Charlotte-Mecklenburg Planning, Design, & Development

DATE: August 14, 2019

SUBJECT: Administrative Approval for Petition No. 2015-088 Charlotte Parker & Marion McGaha

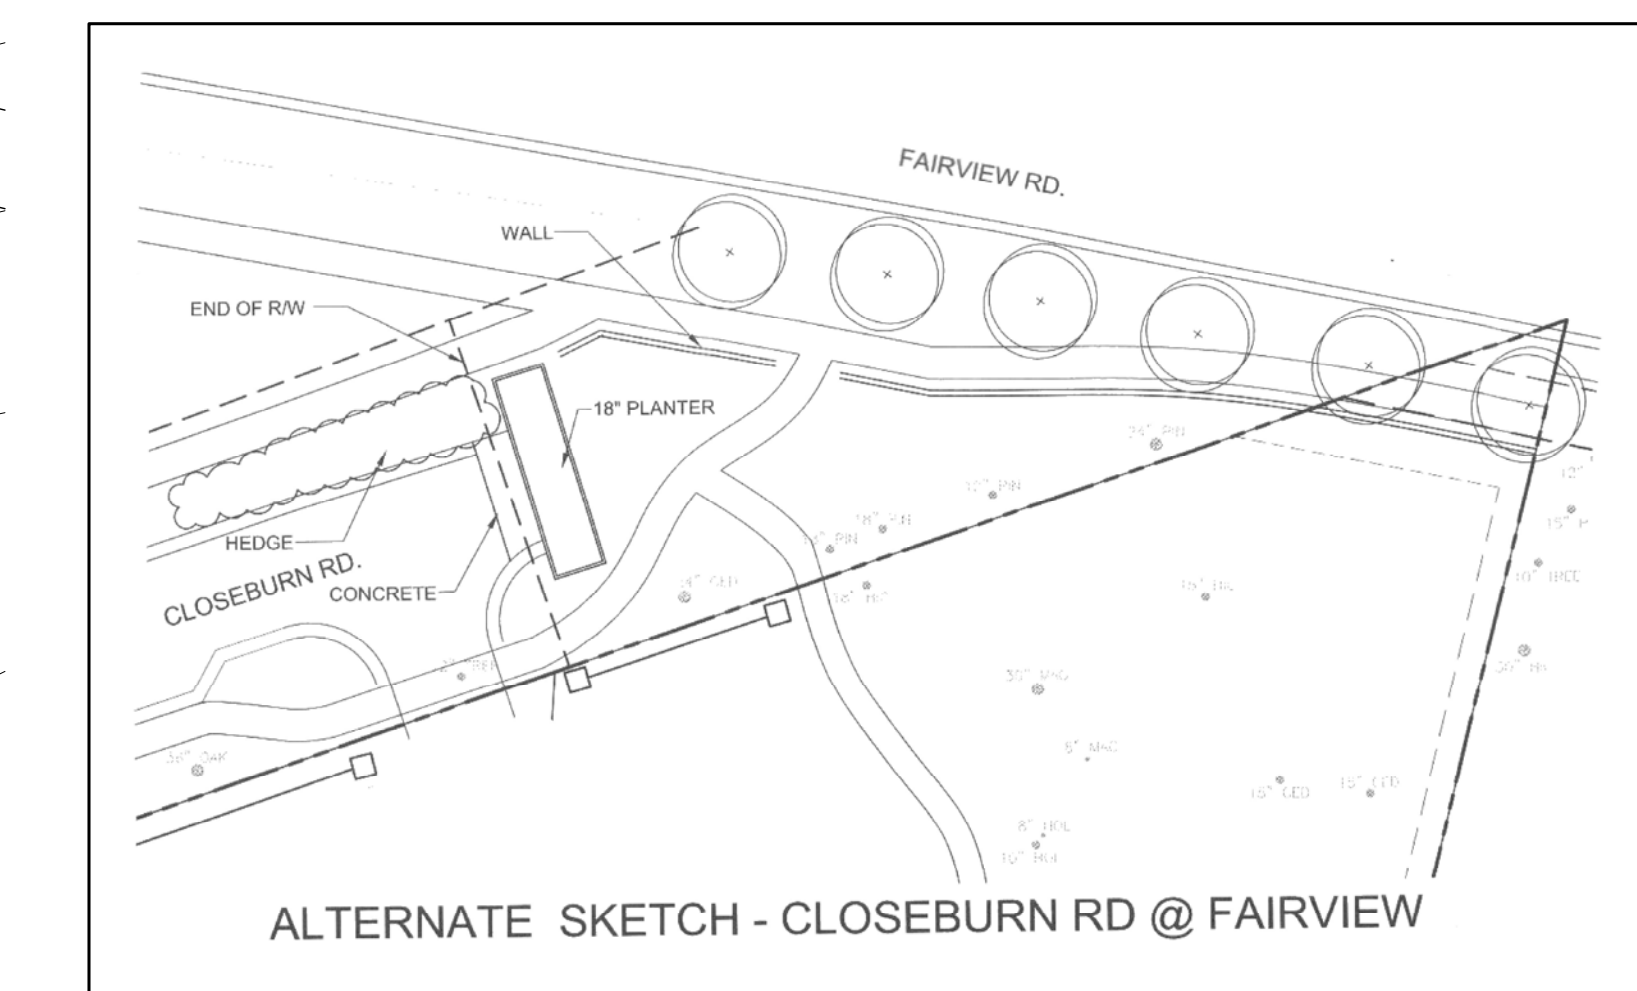
- Allow a modification to the site layout and building configuration.

- The site plan complies with the conditional notes and still meets the intent of the original approval by the City Council.
